Sketch 1

MACC 0414

Project # 16MO75CN

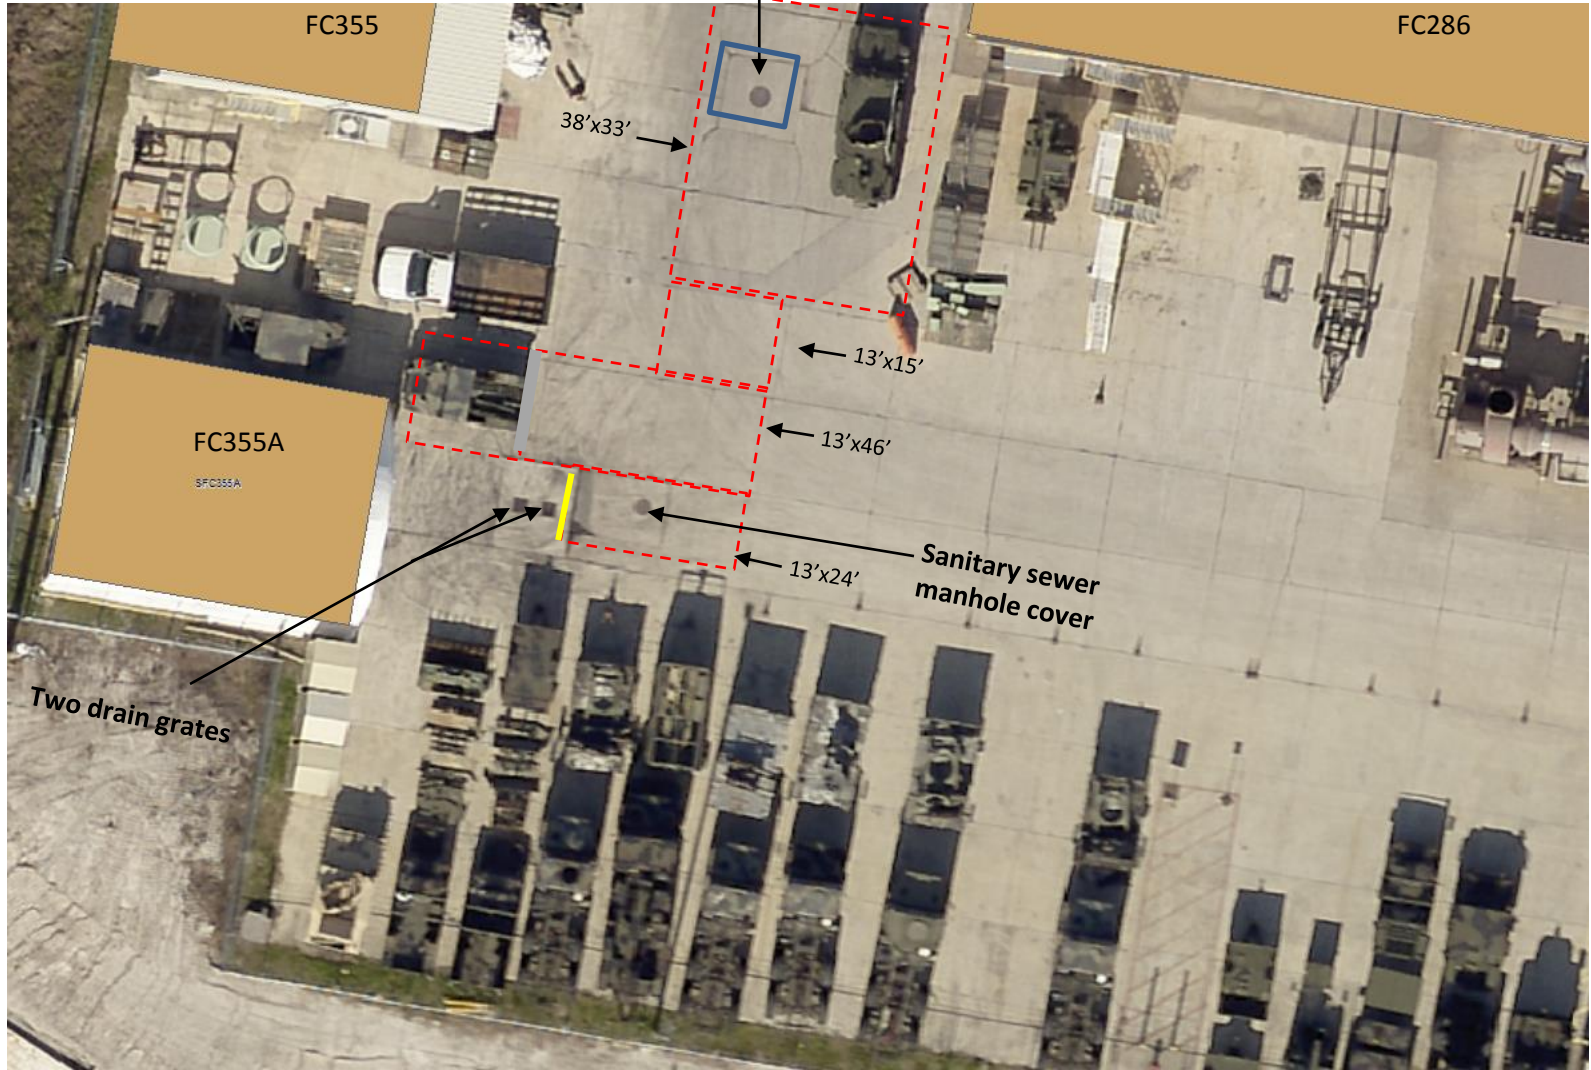
-  Contract has sank 2 inches
-  Demo concrete and replace
-  Concrete shall remain (10' x 10')

Sketch 2
 MACC 0414
 Project # 16MO75CN

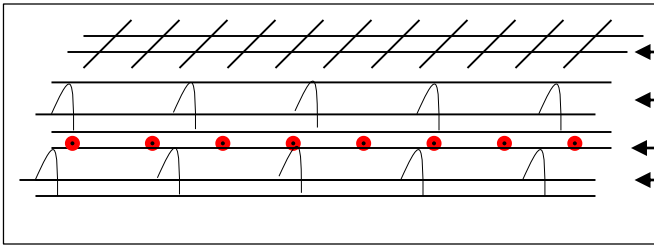
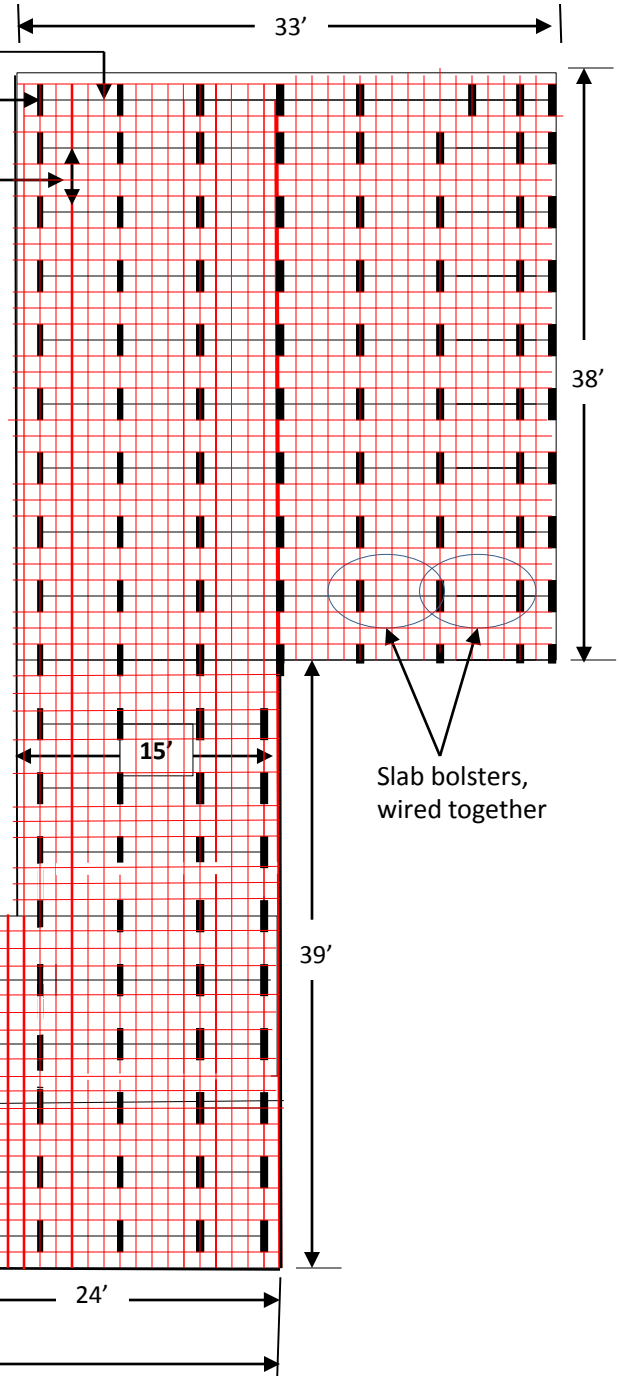
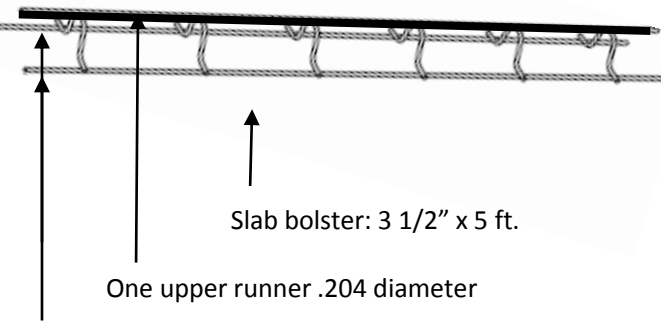
Slab bolsters shall be placed within 3 inches from exterior +/- 1 inch around the entire exterior perimeter where new concrete shall be poured.

Maximum distance between parallel runs of wired together slab bolster uppers shall not exceed 4 ft.

Multiple slab bolster uppers (3 1/2" x 5 ft.) wired together

#6 Rebar shall be overlapped 2 ft. minimum where it overlaps
